South Humber Bank Energy Centre Project

Planning Inspectorate Reference: EN010107

7.7 - Statement of Common Ground with Network Rail

Applicant: EP Waste Management Ltd
Date: December 2020

Figure 1: Designated HGV Route

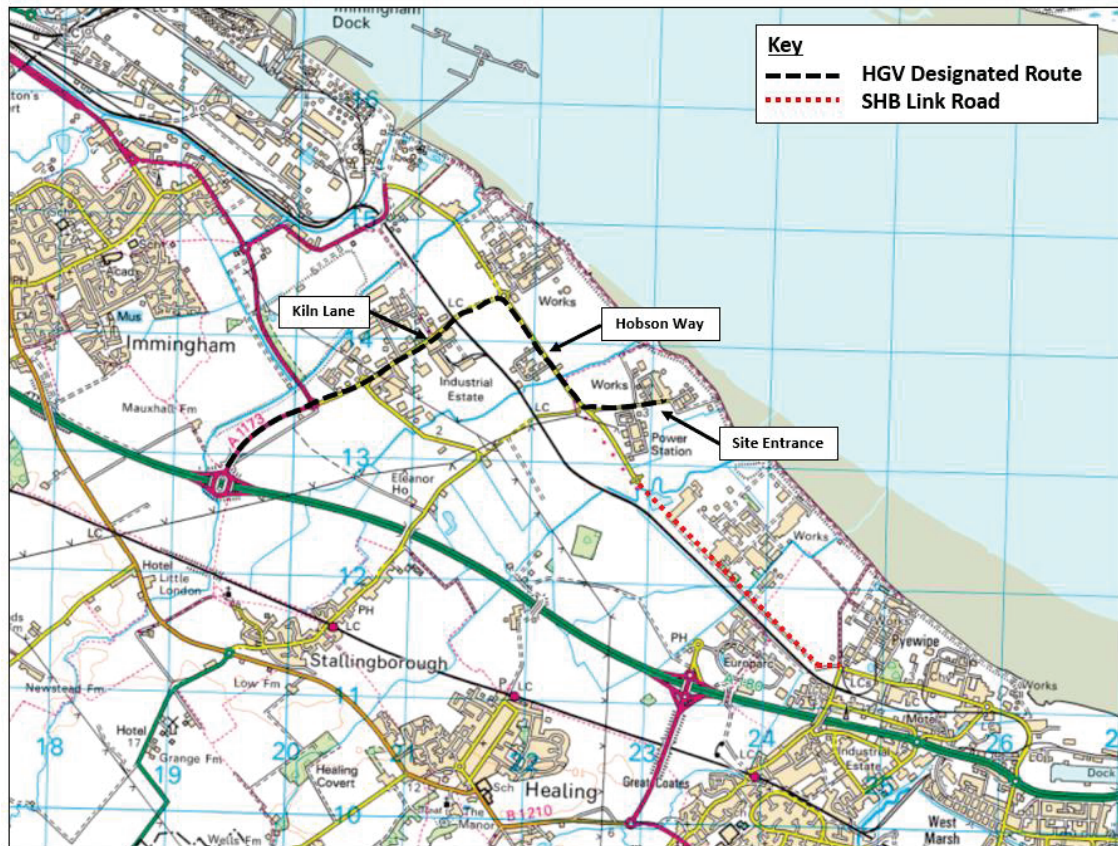
Network Rail comment	Information provided by Applicant in this Technical Note
	Road (west of Hobson Way).
<p><i>“The Kiln Lane level crossing fairs a little better. The Western approach, whilst improved from the east, has its own difficulties. The route is via a large and busy industrial estate. From a brief desktop review, it appears that there are a high proportion of businesses that either service or would require deliveries by LGV/HGV. As you will imagine, this brings in a significant number of LGV/HGVs, and using this as your preferred route, will only exacerbate traffic volumes. Your traffic modelling also shows projected movements of 17 HGV’s per hour in each direction, or one every 1¾ minutes. This significantly increases the chance of head on meets between vehicles and the potential for vehicles to ‘back up’ over the crossing.</i></p>	<p>As above, the Applicant awaits further information from Network Rail.</p> <p>See paragraph 1.3.6, paragraphs 1.5.5 to 1.5.6, and Sections 1.7 to 1.8 for consideration of the suitability of Kiln Lane and Kiln Lane level crossing for Proposed Development traffic, and Proposed Development construction and operational traffic impacts on Kiln Lane.</p>

<p><i>Your vehicle modelling states ‘PCU’ Passenger Car Units, however HGV are two to three times the length of PCUs, therefore I argue that your Max Queue output is skewed and does not accurately represent the scenario with HGVs.”</i></p>	<p>See paragraphs 1.7.5 and 1.8.1 for explanation of how PCUs are used in the Transport Assessment.</p>
<p><i>“Given as noted in the first paragraph, please can you provide evidence that you have reviewed the route via the north and submit robust reasoning behind your evaluation and decision.”</i></p>	<p>See Section 1.6 for information on alternative HGV routes.</p>
<p><i>“Lastly, I notice that your report identifies a southern access via the A180, Westgate roundabout and Moody Lane, where no mitigation is proposed due to the ‘small percentage that development flows are adding to the junction’. I would like to understand further why this could not be a preferred route. It appears to provide a suitable route that needs no upgrade to proposed figures, whilst not requiring the use of a level crossing and more of the access via A Class roads.”</i></p>	<p>See Section 1.6 for information on the alternative HGV route via Moody Lane.</p>
